Water Right Conditions
Tracking Slip

FILE # # G-18089

PUBLIC INTEREST REVIEW FOR GROUNDWATER APPLICATIONS

TO: Water Rights Section Date 08/20/2015
 FROM: Groundwater Section Jen Woody
 SUBJECT: Application G- 18089 Reviewer's Name Jen Woody
 Supersedes review of n/a Date of Review(s) _____

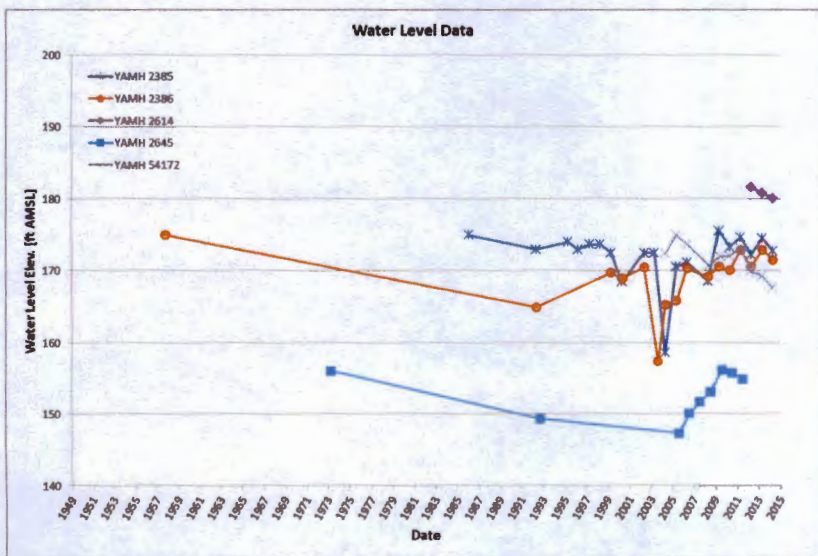
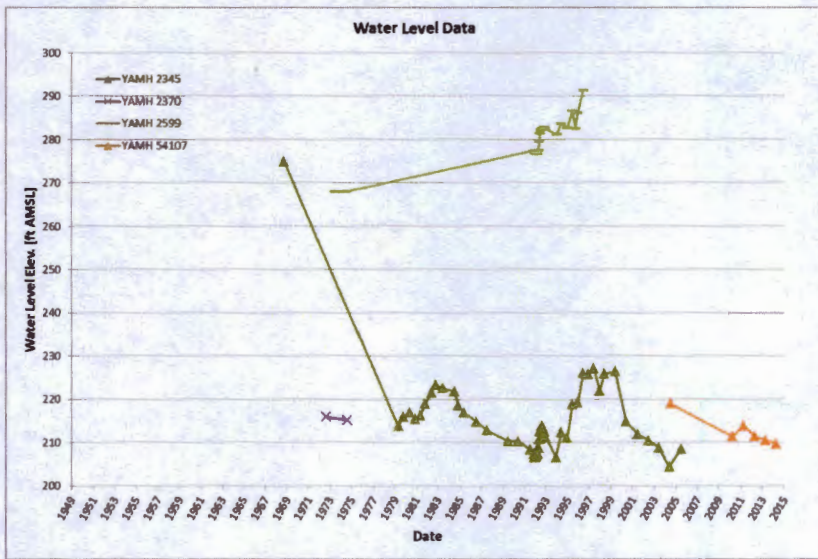
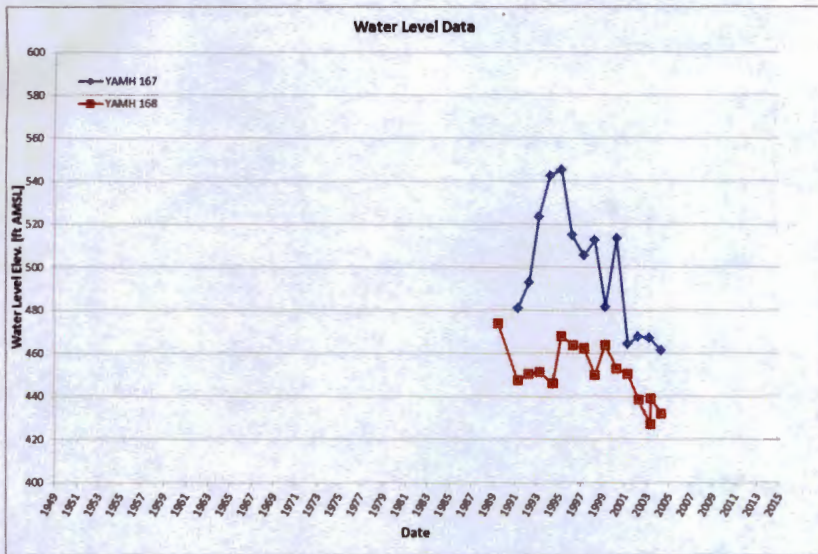
Water level data from the 9 sections around the subject well are shown in Figure 2. Trends are predominantly stable, with a few exceptions. The proposed POA's proximity to two CRBG Groundwater Limited Areas and the mixed water level trends suggest the need to conduct further water level monitoring. Condition 7I addresses this uncertainty.

Figure 2. Water level trends are mixed in nearby CRBG wells. Data from CRBG wells in T3S/R2W-Sections 14, 15, 16, 21, 22, 23, 26, 27, 28 are displayed. The subject well, YAMH 54107 shows a slight downward trend from 2010 to 2015 (the well log measurement is questionable, as discussed in C1). YAMH 167 and 168, located in the Parrett Mountain Groundwater limited Area show a downward trend from 1989 to 2006. Other nearby wells with water level records have relatively stable trends at the current level of use.

- i. The permit should contain condition #(s) 7I, and Large Water Use Reporting;
 - ii. The permit should be conditioned as indicated in item 2 below.
 - iii. The permit should contain special condition(s) as indicated in item 3 below;
